# Service Bulletin

Bulletin No. 2007-66R1  
CMD 2007-06R1

## Official Recall Notification U.S. Federal Boat Safety Act—QSD 4.2 ECM Bolt Interference with Fuel Line

#### Locations of possible interference

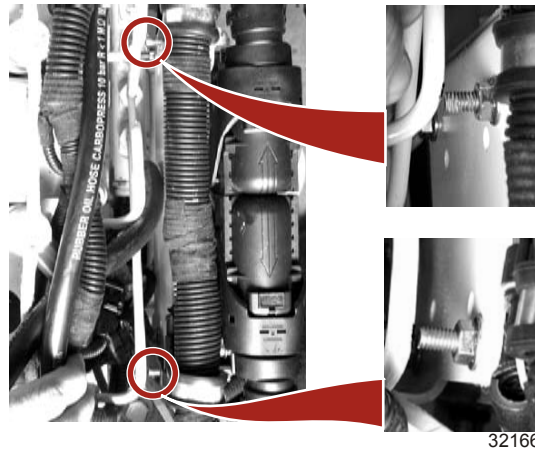
The Engine Control Module (ECM) mounts to a bracket using rubber vibration dampers with threaded studs at both ends. Engines within the serial number range have ECM vibration dampers with studs that are of equal length on both ends. When the ECM vibration dampers are installed, the studs attaching the vibration dampers to the ECM mounting bracket may protrude far enough to make contact with the high pressure fuel lines for cylinders number 1 and 3.

3. Inspect for interference with the top two vibration damper studs and the high pressure fuel lines for cylinders number 1 and 3 . Replace fuel lines that are damaged. Refer to the appropriate CMD engine service manual.
4. Cut the plastic cable ties anchoring the ECM harnesses to the ECM mounting bracket (if equipped).
5. Disconnect the two harness connectors from the ECM.

Replace all four ECM vibration dampers with new parts that have a shorter stud length on one side. Inspect the high-pressure fuel lines for damage and replace them if necessary. Refer to the procedure below.

**Vibration damper with short stud toward engine**

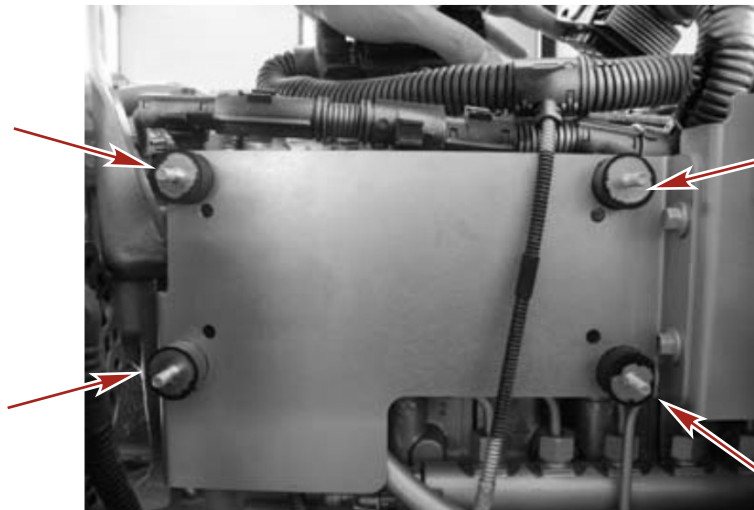
8. Install the four new vibration dampers with the shorter stud toward the engine.
